City of Tacoma

**ADDENDUM NO. 2**

**Request for Bids Specification No. PW23-0090F  
TPU S 17th St Court D/E**

PWR-01216  
SHEET NO. 7  
SHEET DTL-4 OF DTL-4

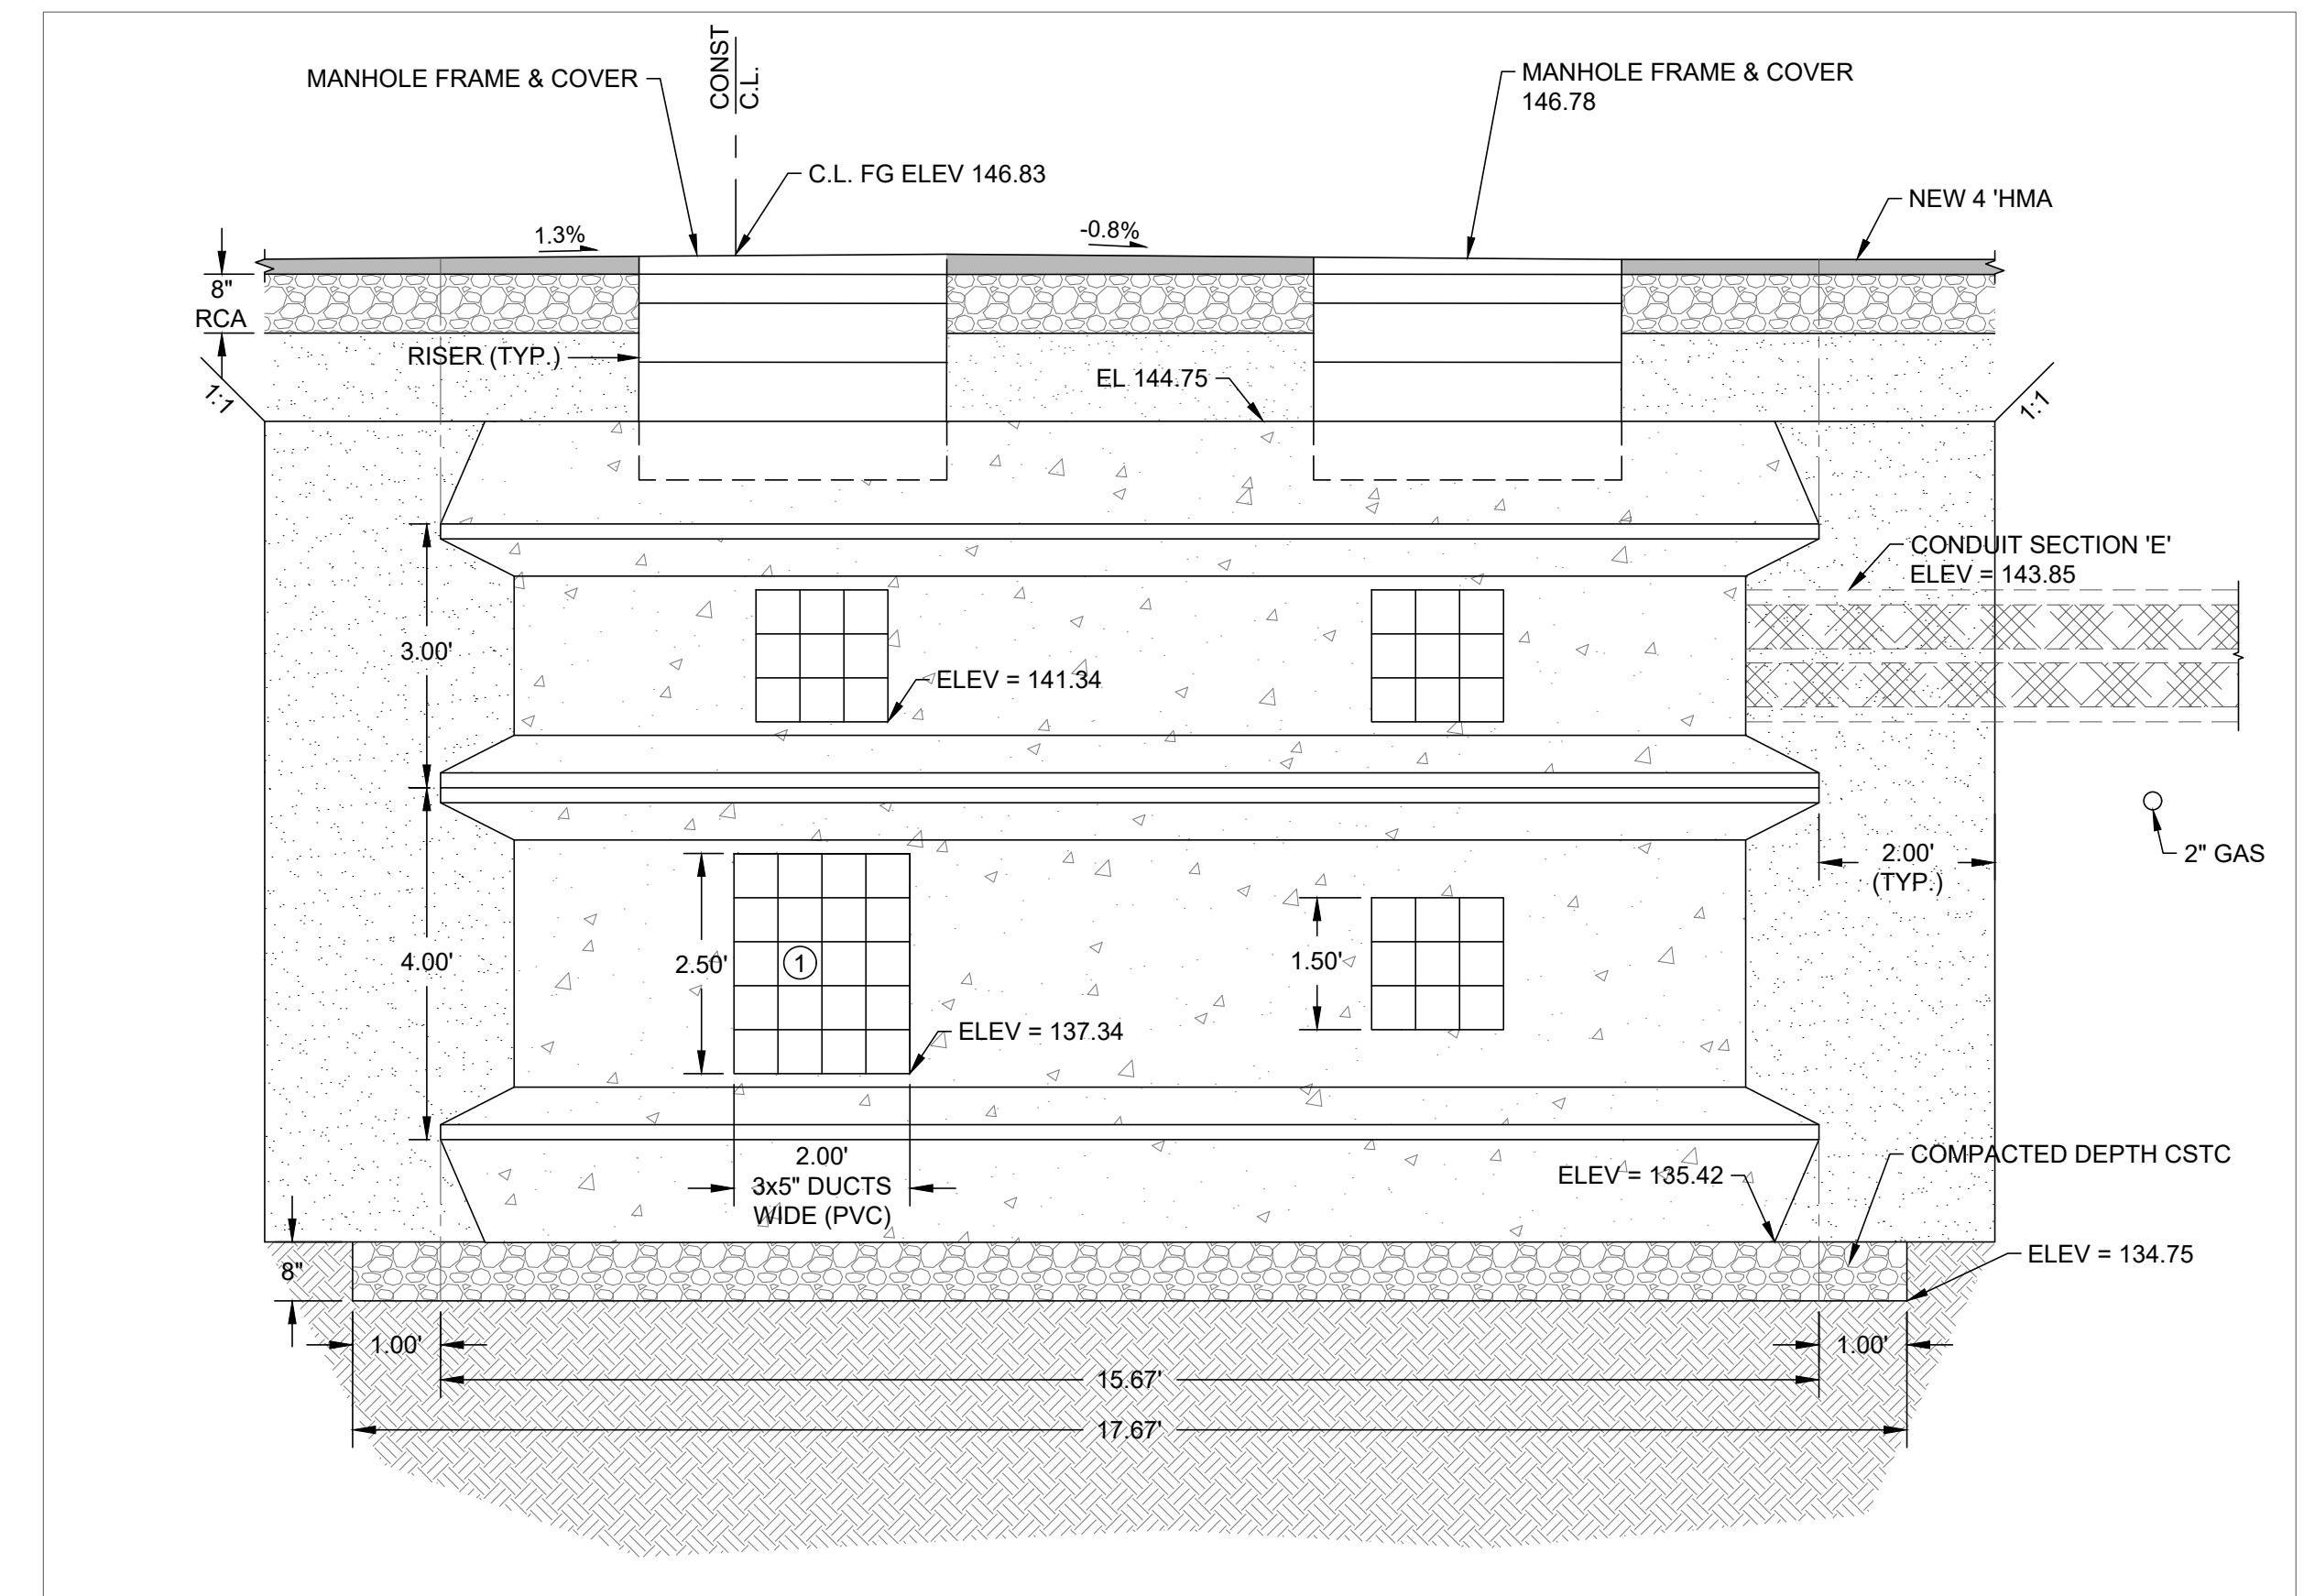
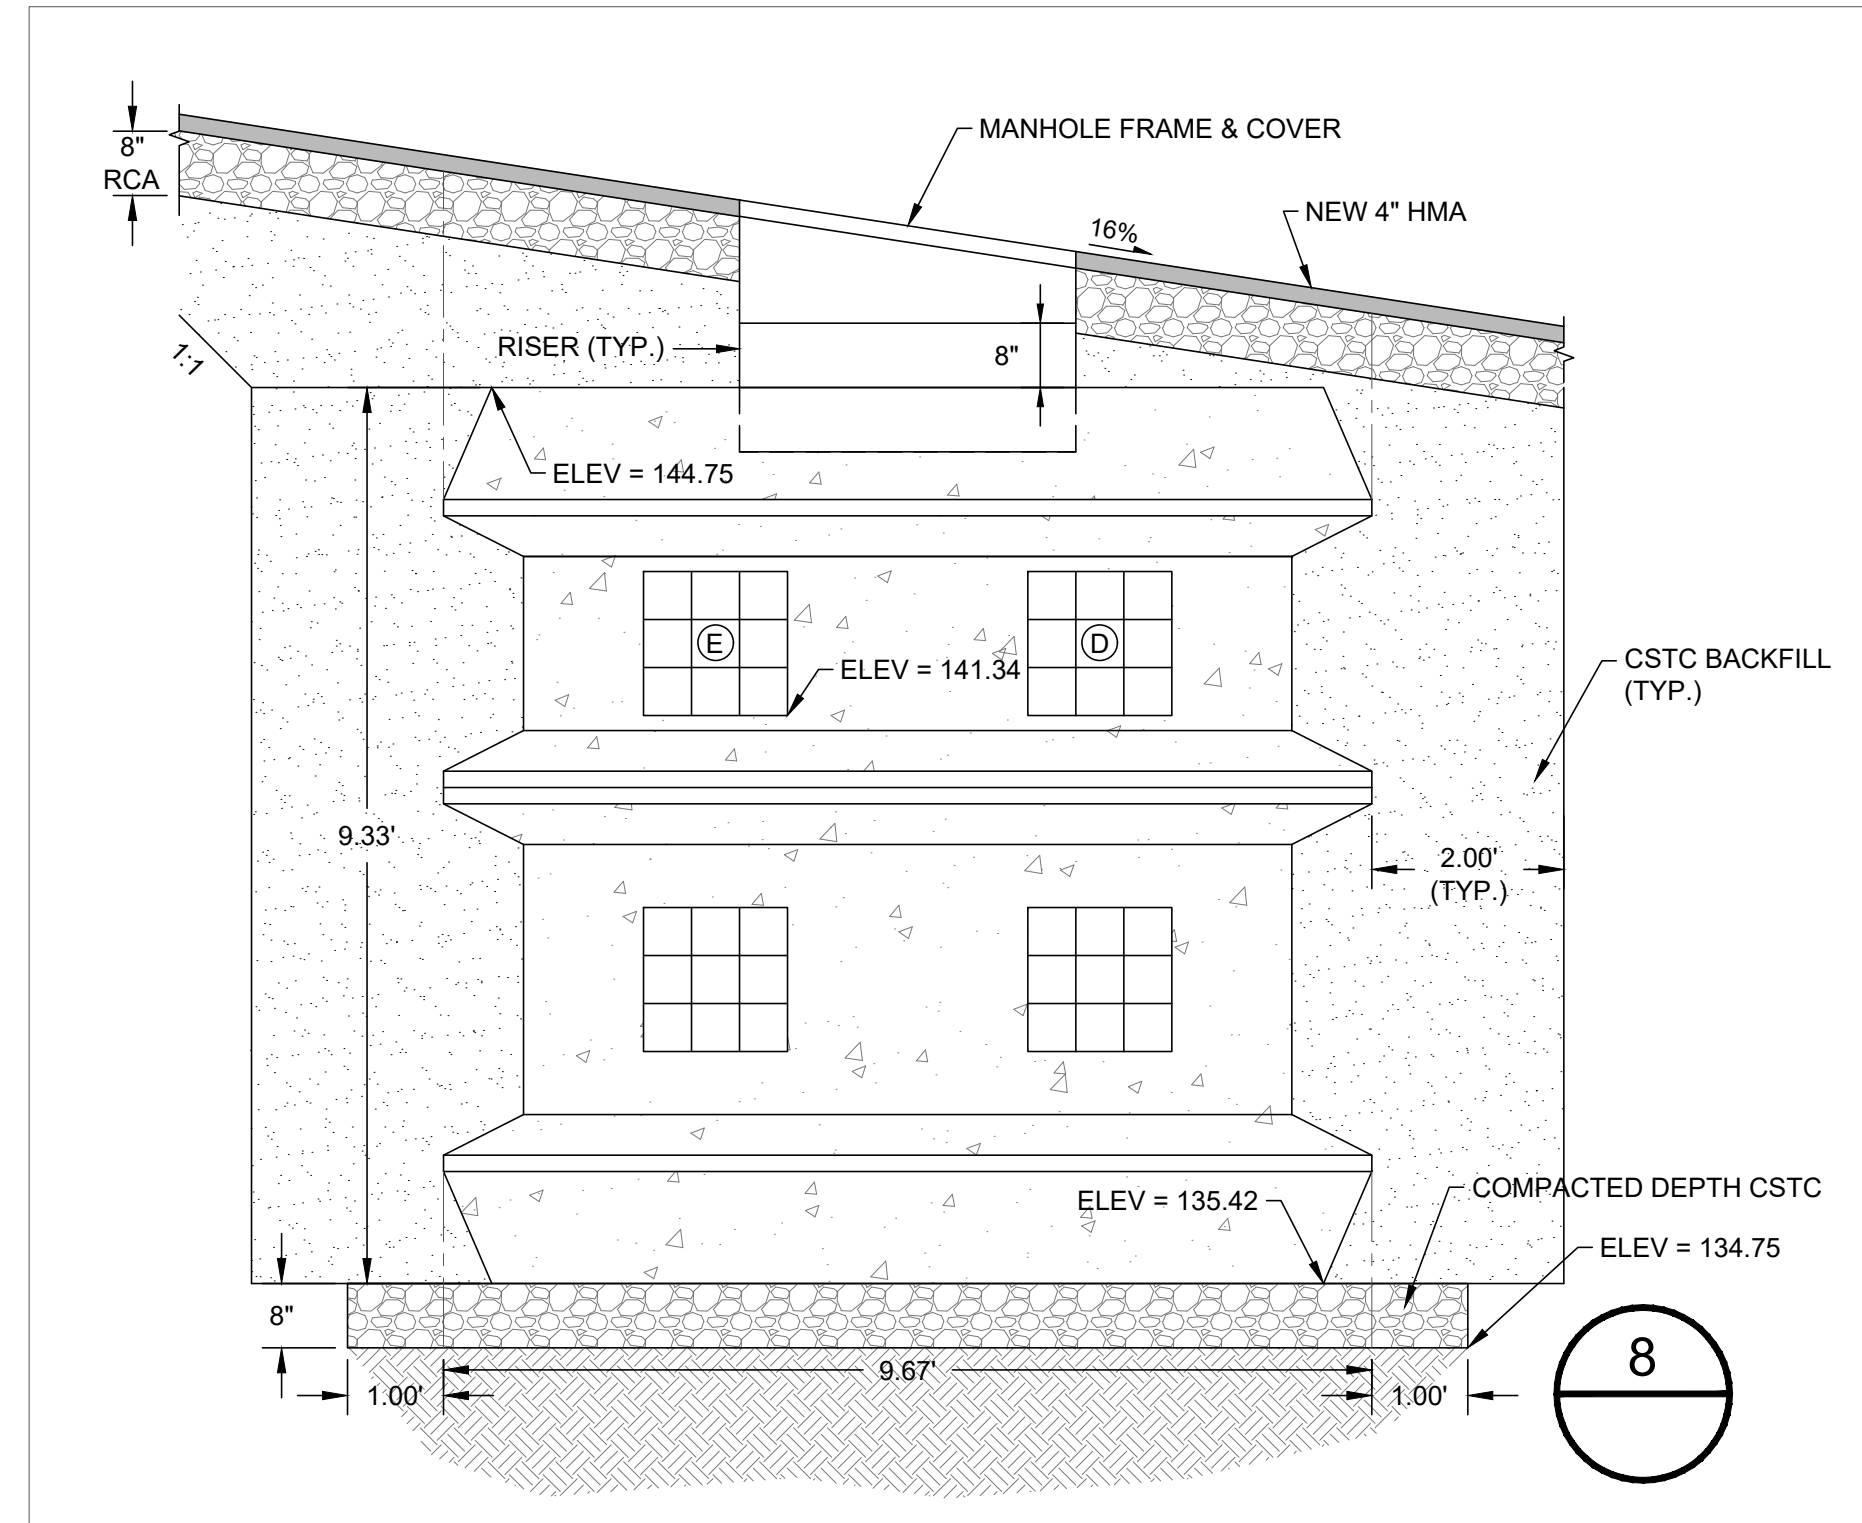
1. Sheet No. 7 / Sheet DTL-4 of DTL-4
2. Sheet No. 8 / Sheet D-1 of D-1
3. Sheet No. 10 / Sheet C-2 of C-2
4. Sheet No. 12 / Sheet PW-1 of PW-1

NOTE:  
CONTRACTOR SHALL VERIFY WITH  
MANUFACTURER SHOP DRAWINGS FOR  
ACCURATE FOUNDATION ELEVATIONS  
AND EXCAVATION LIMITS
